STATE OF CONNECTICUT CONNECTICUT SITING COUNCIL

APPLICATION OF CELLCO PARTNERSHIP : DOCKET NO. 484

RESPONSES OF CELLCO PARTNERSHIP D/B/A VERIZON WIRELESS TO CONNECTICUT SITING COUNCIL PRE-HEARING INTERROGATORIES

ATTACHMENT 1

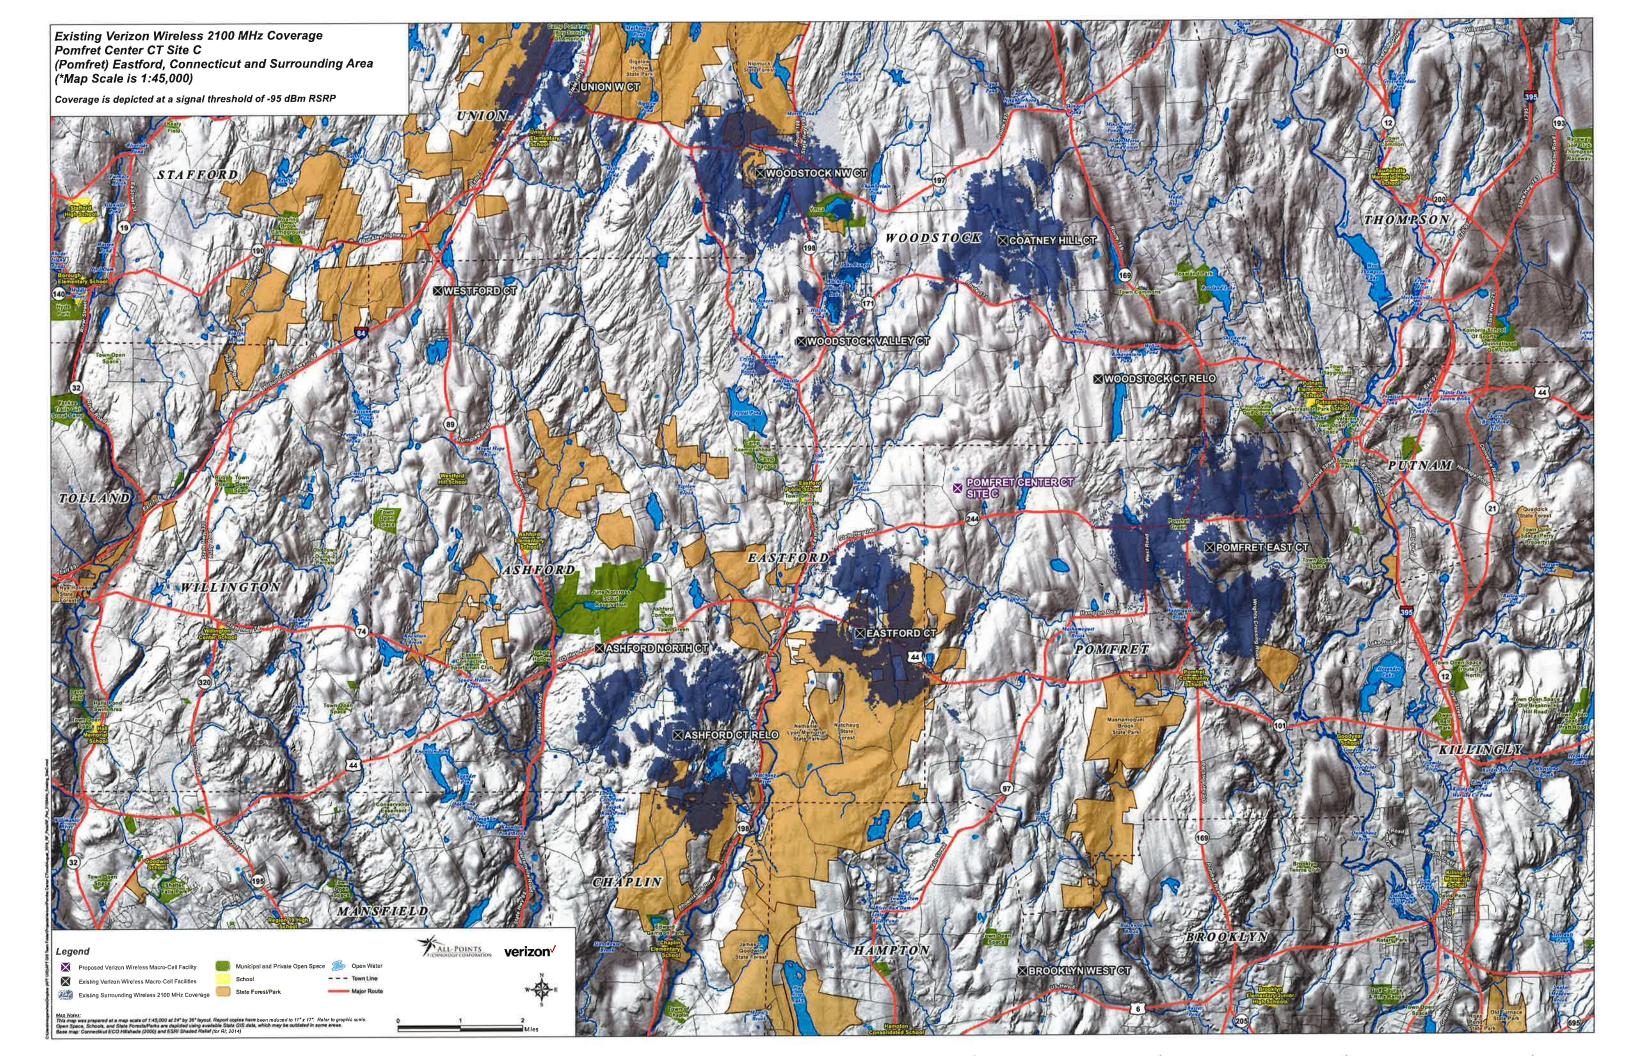
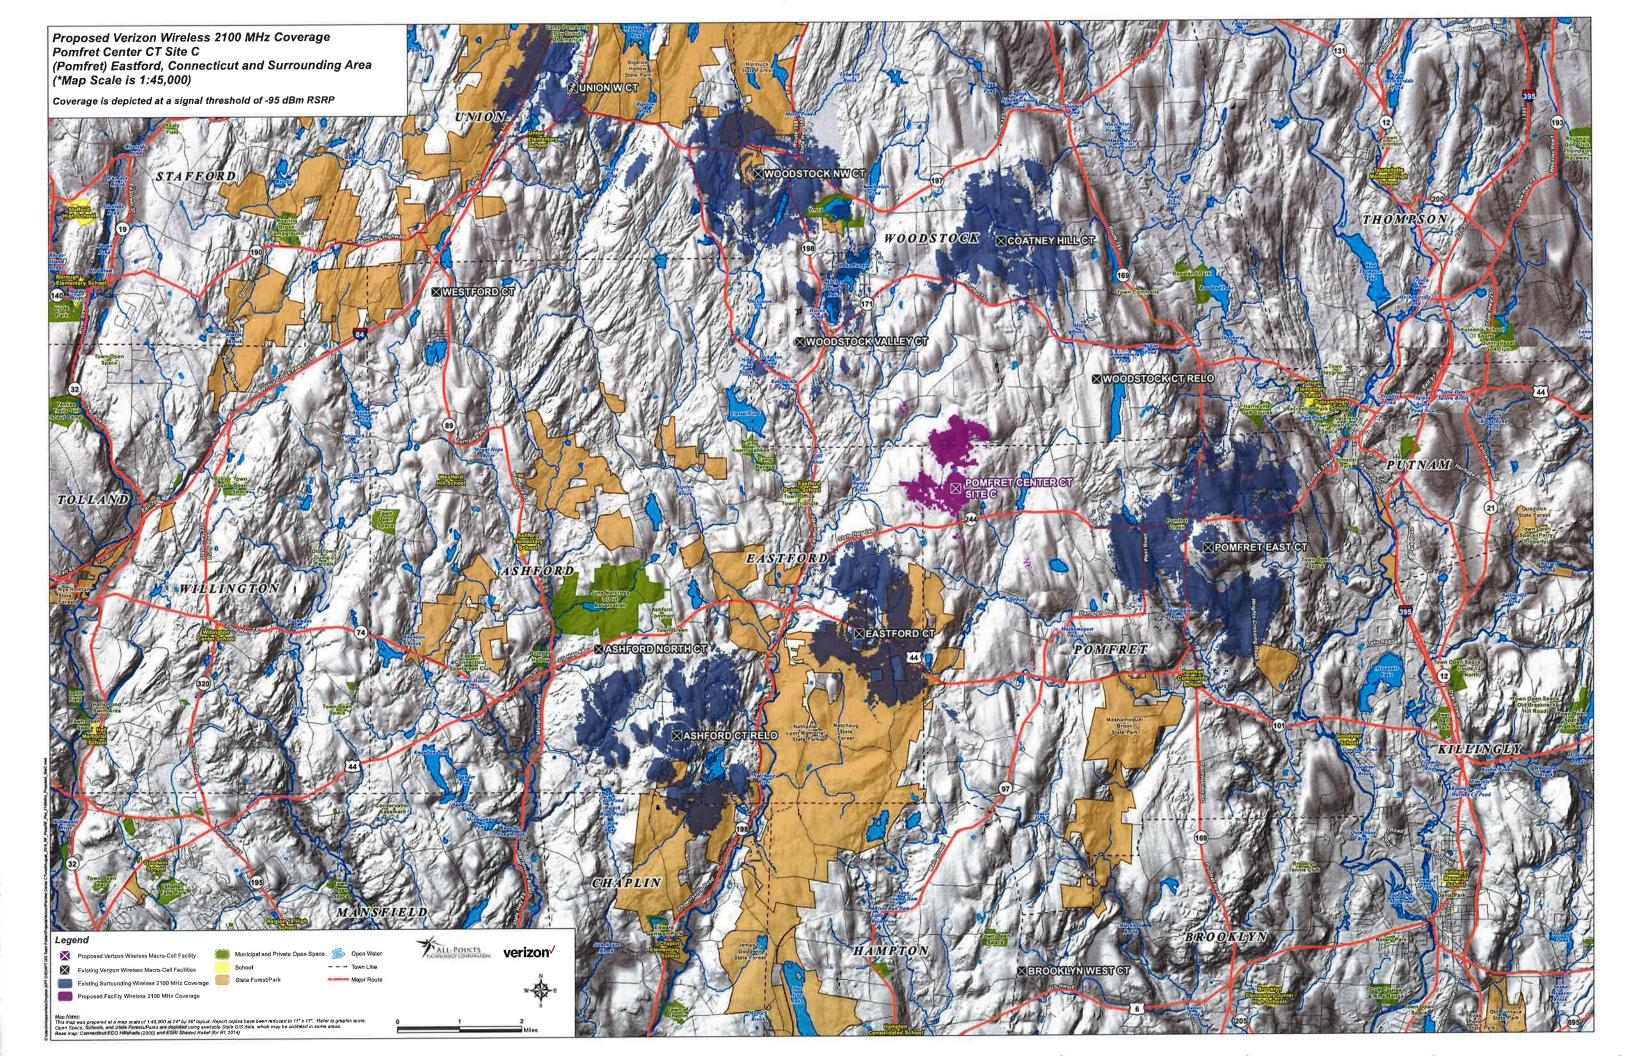
Referring to Application Tab 6 - 700 MHz coverage plots, the coverage plots do not appear to show any 700 MHz service from the "Eastford CT" site. Is this Cellco site active? What services is it providing?

Yes, the Eastford CT site is currently active. Coverage from Cellco's Eastford CT and its newly constructed Woodstock Valley cell sites was inadvertently excluded from the coverage plots that Cellco included in the Application. Revised coverage plots, showing 700 MHz and 2100 MHz service from the all of the adjacent cell sites, including Eastford and Woodstock Valley, are included in Attachment 1 of these responses.

ATTACHMENT 2

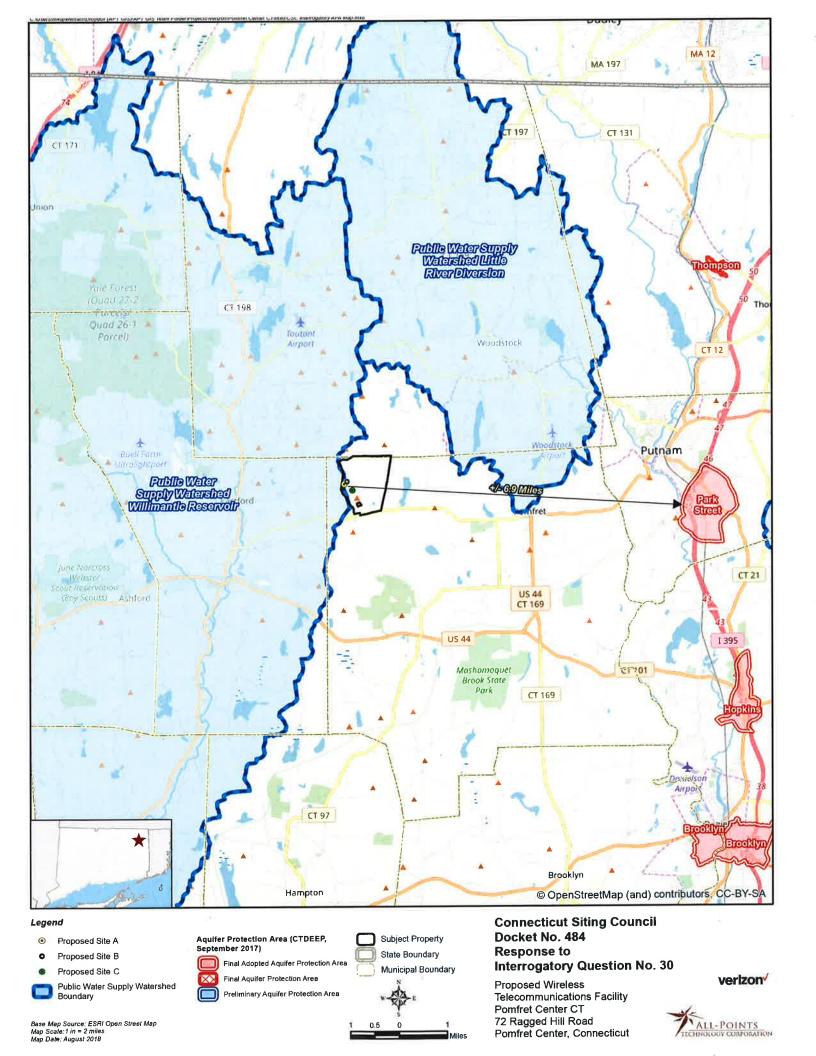
Is the proposed facility within a Department of Energy and Environmental Protectiondesignated Aquifer Protection Area ("APA")?

No. The nearest APA is nearly 7 miles to the east. None of the alternative site locations presented in the Application are located within a public water supply watershed. The Willimantic Reservoir Public Water Supply Watershed abuts Swedetown Road and Ragged Hill Road immediately west of the Property. *See* Attachment 2.

Connecticut Siting Council Docket No. 484 Response to Interrogatory Question No. 33 - SITE A

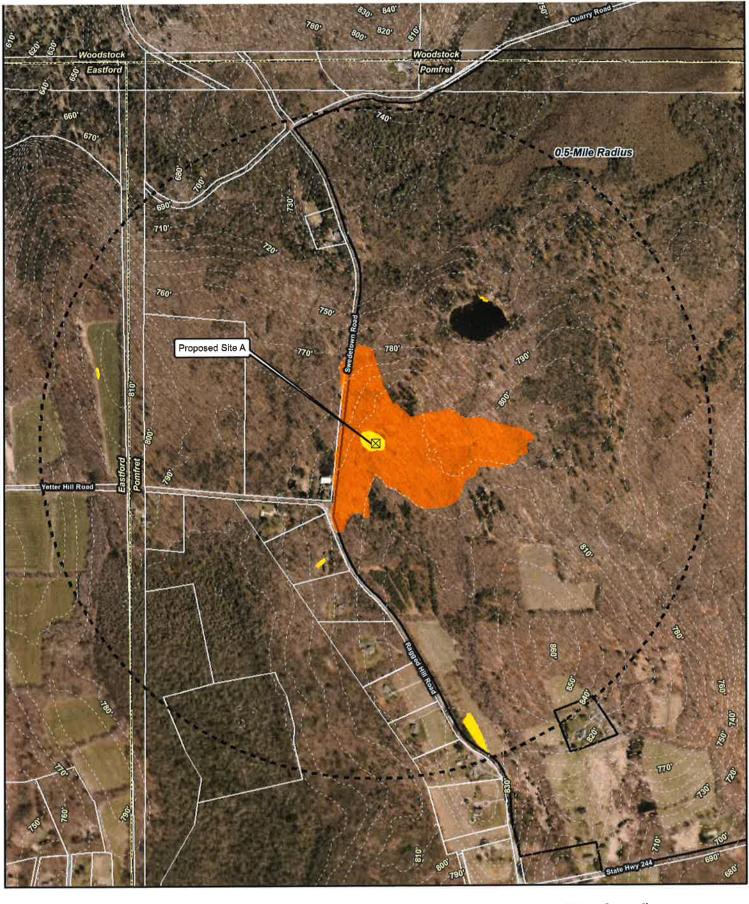
Referring to Application Tab 9, the Photo-log shows open field areas within a 0.5 mile radius of the proposed sites. Provide predictive visibility mapping, using a 0.5 radius around each site, that depicts potential year-round and seasonal visibility of the proposed towers. How many residences are within these areas?

Predictive visibility maps depicting seasonal and year-round visibility of a tower at each of the three optional sites are provided in <u>Attachment 3</u>. The requested 0.5-mile radius includes a total of 502 acres. In total, less than 7% of the acreage may have views of a tower at any of the alternative locations, the vast majority being seasonal views (through the trees) from undeveloped land on the Property. The dense, mature tree cover in the area would effectively screen a tower from eclipsing the tree canopy within this radius. The predictive model suggests one residential property to the west may have a very limited view of the tower from a portion of the side yard. A summary of the visibility mapping results is provided below.

SITE A

Year-Round Visibility = 1.1 Acre

Seasonal Visibility = 23.9 Acres

Total Residences within 0.5 mile = 9
